# CITY OF BURIEN, WASHINGTON

## RESOLUTION NO. 327

### A RESOLUTION OF THE CITY OF BURIEN, WASHINGTON, ENTERING FINDINGS OF FACT AND CONCLUSIONS AND CONDITIONALLY APPROVING A TYPE 3 LAND USE REVIEW FOR THE REDEVELOPMENT OF FIRE STATION NO. 29

**TYPE III LAND USE REVIEW  
STAFF RECOMMENDATION TO THE HEARING EXAMINER**

SHEET:  
**L0.0**

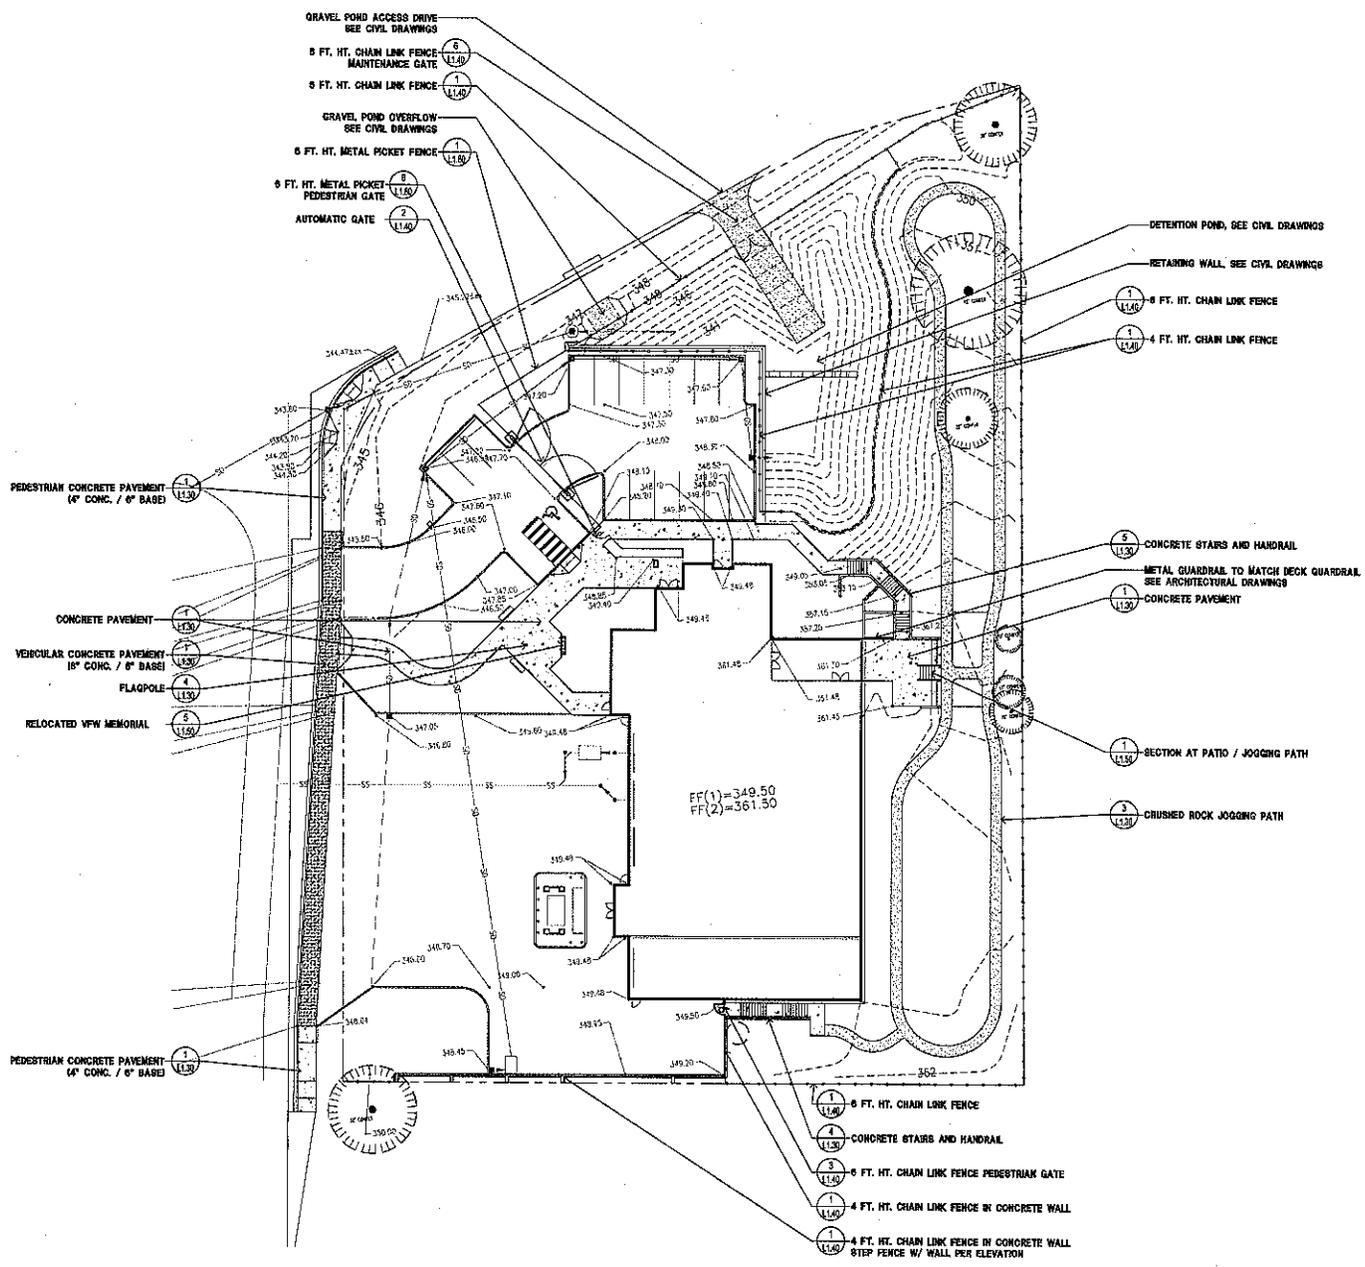
There are 27 existing significant trees on the site. The Applicant submitted a Tree Retention Plan that proposes to retain 6 (or 22%) significant evergreen trees located along the east boundary of the site (see Attachment 3, Sheet L0.0).

The submitted Tree Retention Plan also indicates that 18 significant trees (16 evergreen and 2 deciduous) located on the property immediately adjacent to the southern boundary are also planned to be removed (see Attachment 3, Sheet L0.0). The Landscape Plan

- b. **Conclusions:** The significant tree retention plan meets the City's significant tree retention requirements. All site development plans submitted for the project shall indicate those significant trees to be preserved and shall include all tree protection necessary as outlined in BMC 19.25. Prior to building permit approval, the Applicant shall submit a signed written agreement between the property owner of 18016 Occidental Avenue and Fire District #2 to remove and replace the trees located on the property addressed 18016 Occidental Avenue as shown in the plans (see Attachment 3, Sheet L0.0 & Sheet L2.3).

2. All site development plans submitted for the project shall indicate those significant trees to be preserved and shall include all tree protective measures as outlined in BMC 19.25 (see Conclusion E.4).

3. Prior to issuance of any development permits, the Applicant shall:
  - a. Submit a signed written agreement between the property owner of 18016 Occidental Avenue and Fire District #2 to remove and replace the trees located on the property addressed 18016 Occidental Avenue as shown in the submitted plans (see Conclusion E.4).

SHEET:  
**L2.10**

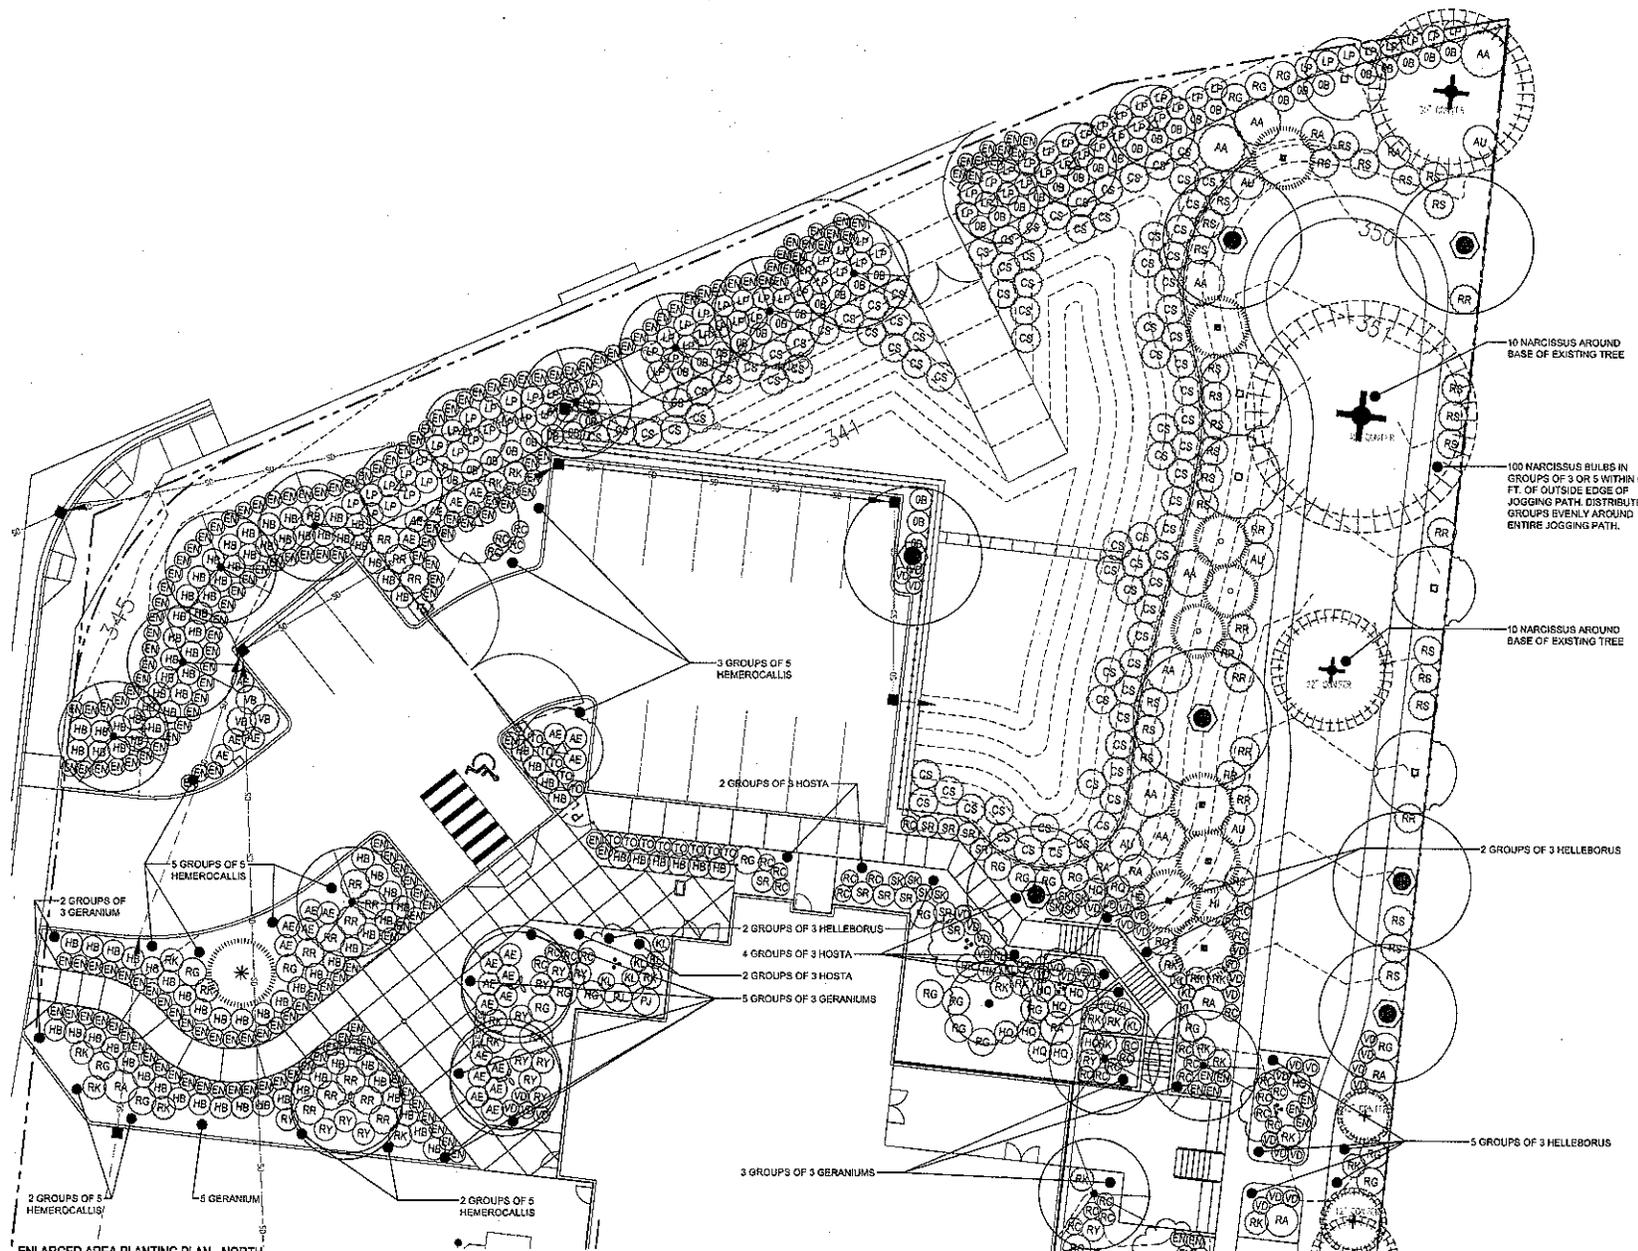
- (1) BMC section 19.15.005 (13) requires the proposal to comply with landscape Category C.
- (2) Category C landscaping requires 10 ft of Type III landscaping along property lines abutting a public right-of-way. Type III landscaping is intended to function as a "see-through-screen" that functions as a partial visual separator to soften the appearance of parking areas and building elevations. The Applicant's submitted Landscape Planting Plan (Attachment 3, Sheets L2.1- 2.5) indicates that plantings of 10 ft or greater of Type III landscaping will be installed along the property line abutting South Normandy Road. The Planting plan does not propose landscaping along the entire property line abutting Occidental Avenue South due to the location of the driveways for the fire engines and onsite parking area. Consistent with BMC 19.25.090, this request complies with the City of Burien's landscaping requirement given that additional landscaping is proposed along the northern and eastern property lines.

- (3) Category C landscaping requires 5 feet of Type IV landscaping along building facades greater than 50 ft. wide. Type IV landscaping is intended to provide visual relief. The planting plan (Attachment 3, Sheets L2.1 - 2.5) indicates that plantings of 5 ft or greater of Type IV landscaping will be installed along most of the facades of the building. The Planting plan does not propose landscaping directly adjacent to most of the western façade due to the location of the garage doors for the fire engines. Consistent with BMC 19.25.090, this request complies with the City of Burien's landscaping requirements given that additional landscaping is proposed along the northern and eastern facades of the Fire Station building (see Attachment 3, Sheets L2.1 - 2.5).

square feet per parking stall. Type IV landscaping is intended to provide shade and visual relief while maintaining clear sight lines within parking areas. The planting plan (Attachment 3, Sheets L2.1 - 2.5) indicates that this required parking area landscaping is deficient by 473 square feet along the northern and eastern sides of the parking area. Consistent with BMC 19.25.090 this request complies with the City of Burien's landscaping requirements given that additional landscaping is proposed to the north and west of the parking area and a 4 foot high chain link fence with screening slats as well as planted climbing vines is proposed along the northern and eastern sides of the parking area to provide additional screening.

\*\*\*Due to retention pond sizing and location requirements, the parking lot perimeter landscaping provided in this plan is less than the required with at the north and east sides of the 13 stall section of the parking lot. This planted area is deficient 473 square feet. The planted area to the north and west of the parking lot (between the 10 foot Type III buffer and the parking lot perimeter buffer) is larger than required and is intended to be averaged with the lesser perimeter landscaping provided. This area is 1762 square feet. In addition, a 4 foot high chain link fence with screening slats is indicated within the narrower perimeter landscaped areas at the north and east side of the lot to provide additional screening as well as fulfilling the requirement for a fence around the pond. Climbing vines are planted along the fence. Groundcover in this area is intended to drop over the sides of the retention pond wall to soften the visual impact of it.

5. Prior to final inspection and issuance of an occupancy permit, the Applicant shall:
  - a. Install the required landscaping and irrigation system consistent with the approved plans (see Conclusion E.5)

SHEET:  
**CH1.1**  
5107-CH1.1.dwg

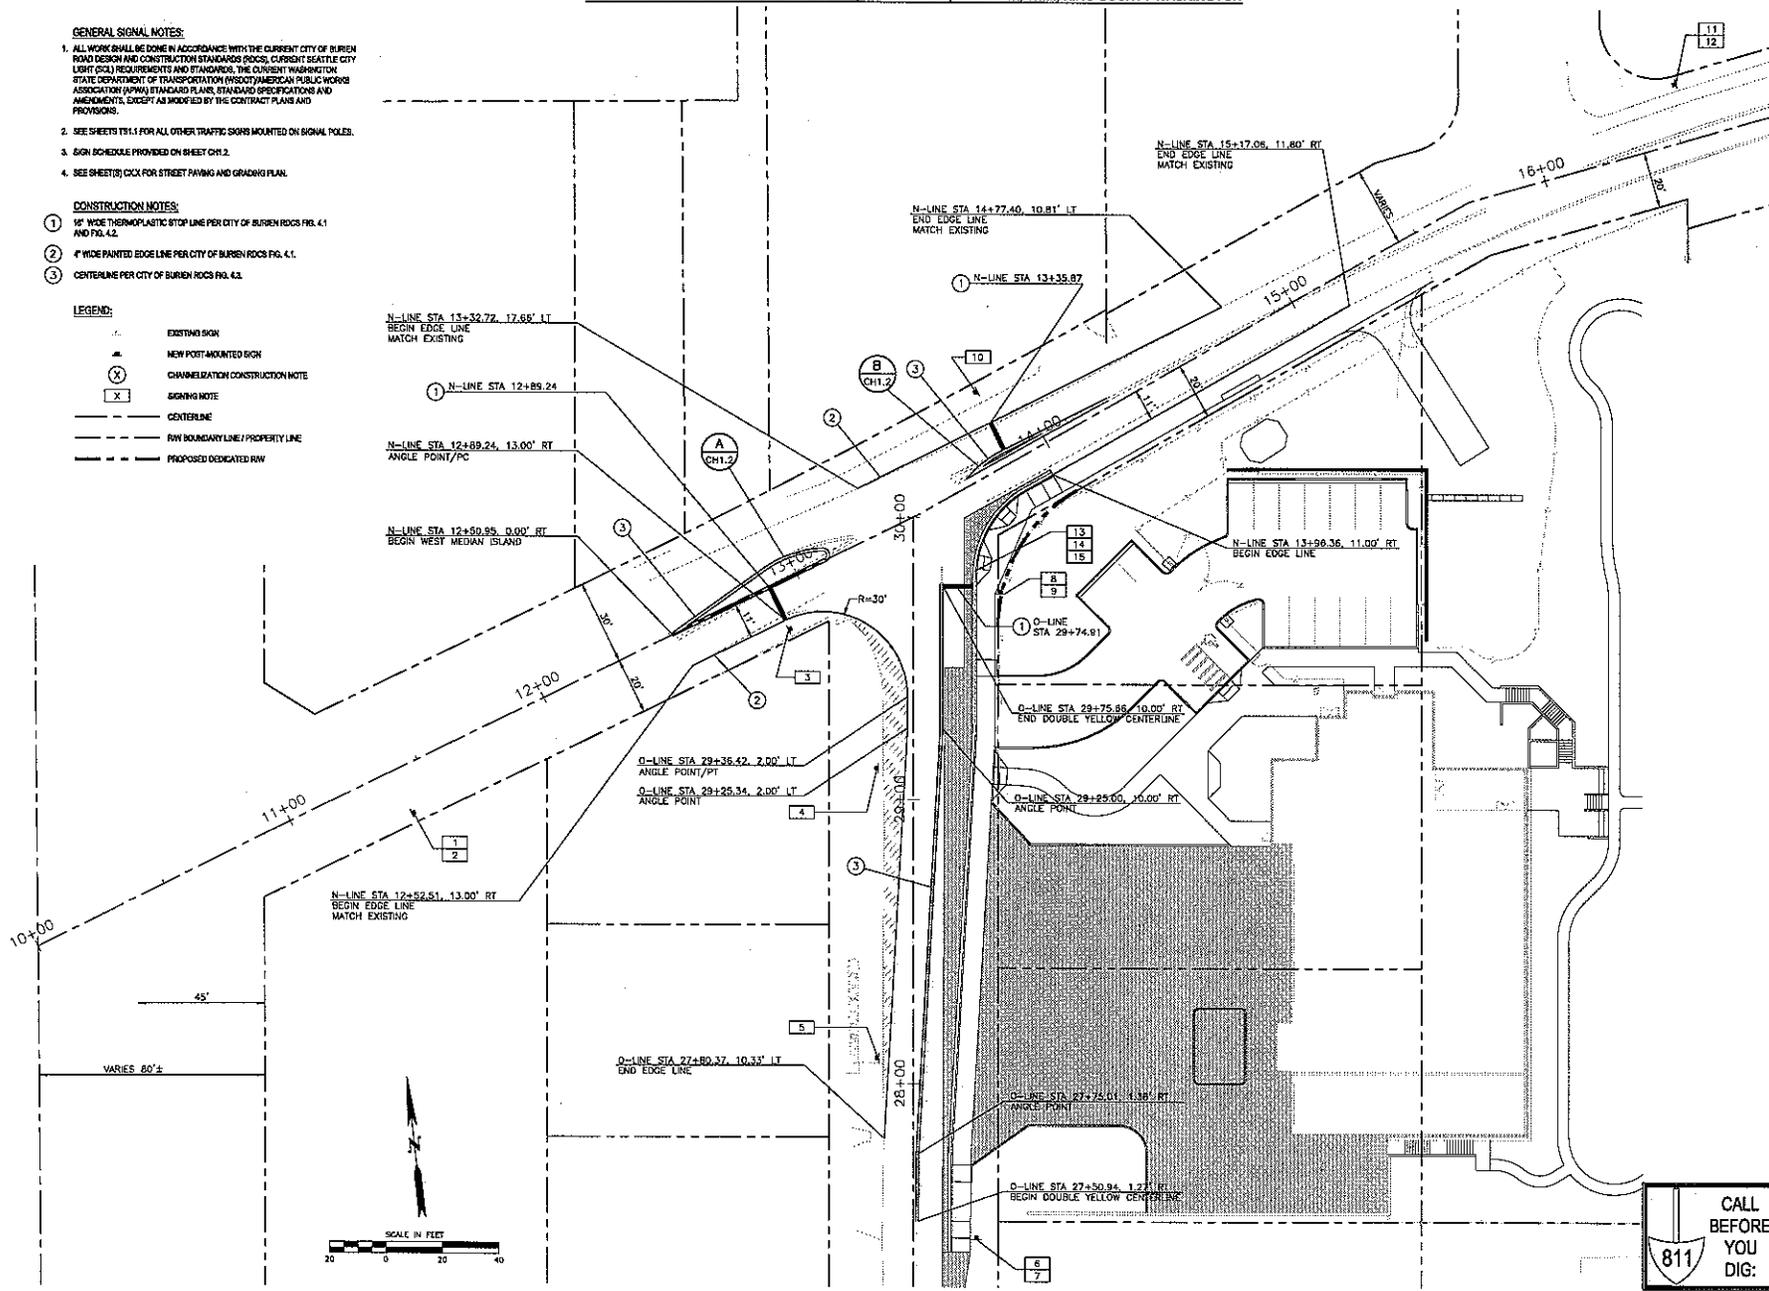
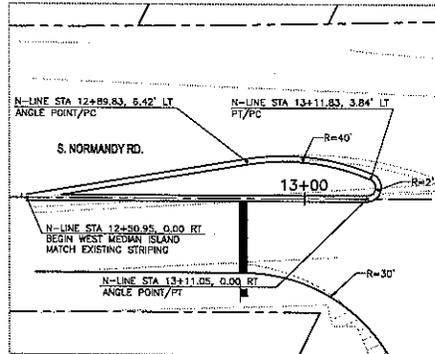
1. The plans show the turning wheel path(s) for the fire apparatus. The direction of travel is not identified, but we assume the lines shown are for vehicles exiting the station. Similar diagrams shall be provided for vehicles entering the station. We have several concerns regarding the turning radius for this station:

- i. It does not appear that the inside wheel path is shown at the station for either the southbound or northbound exit from the station.
    - ii. The design for frontage improvements identifies two 12-foot travel lanes, with a paved shoulder on the west side of Occidental Avenue and a vertical curb and gutter on the east side. The wheel paths on the drawings appear to show the outside wheel in the gutter and the inside wheel on the road centerline. If the fire apparatus is truly 12 feet wide, then the travel lanes should be wider to avoid collisions with other vehicles.

2. The plans indicate that Occidental Avenue will be signed "No Parking" on the west shoulder across from the station. We presume this is to accommodate the wide turning radius required for the fire apparatus. We assume that residents of these two homes are accustomed to parking in front of their homes; therefore, the applicant should identify where the homeowners might park. Otherwise, enforcement may become a problem.

- c. Submit detailed access and frontage improvement plans for the project, including curb, gutter and sidewalks for review and approval by the City's Public Works Department. The plans shall be in accordance with the 2008 Burien Road Standards and address the issues expressed in the City's Development Review Engineer's memorandum dated November 15, 2011 (see Conclusion E.7).

SHEET:  
**C-1**  
 SITE PLAN

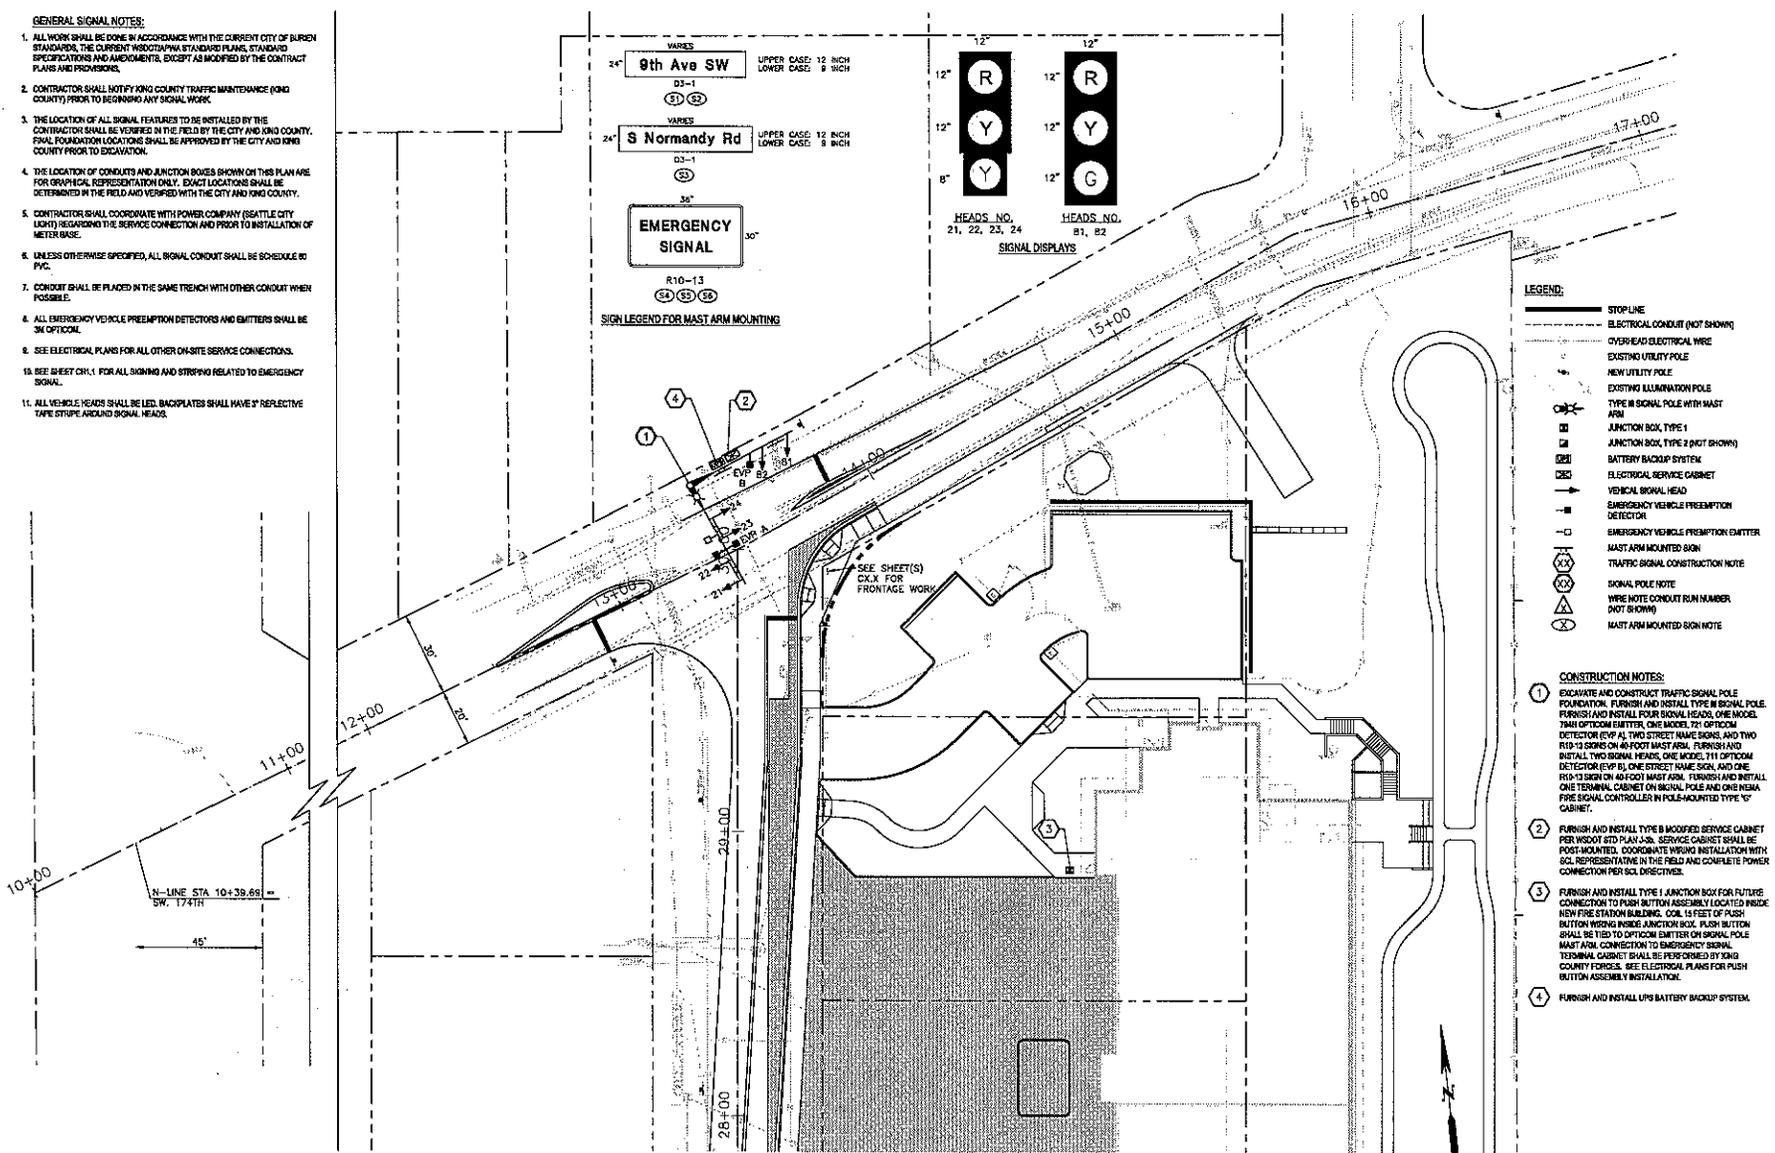
5. The plans do not include design details for the pond and control structure. This information shall be provided.
  6. The TIR identifies that the site resides within the South King County Groundwater Management Area, but that the soils on the eastern part of the site are not suitable for infiltration (glacial till), and the west portion consists of outwash soils. The TIR shall address how the project may be affected by the South King County Ground Water Management Area regulations should it be discovered during construction that the soils in the pond area are permeable. The geotechnical studies for the site should be included in the TIR.

7. It appears that the properties located to the east and south of the site naturally drain onto the project site. The plans should indicate how this runoff will be collected and conveyed through the property in the future. Future development of these parcels may require an easement through the site, as the right to drain for those properties cannot be impede by the downstream property.

- d. Submit detailed stormwater improvement plans designed in accordance with the 2009 King County Surface Water Design Manual as adopted by the City, for review and approval by the City's Public Works Department. The Plans shall address the issues expressed in the Development Review Engineer and Surface Water Management Engineer memorandums dated October 26, 2011 and November 15, 2011 (see Conclusion E.8).
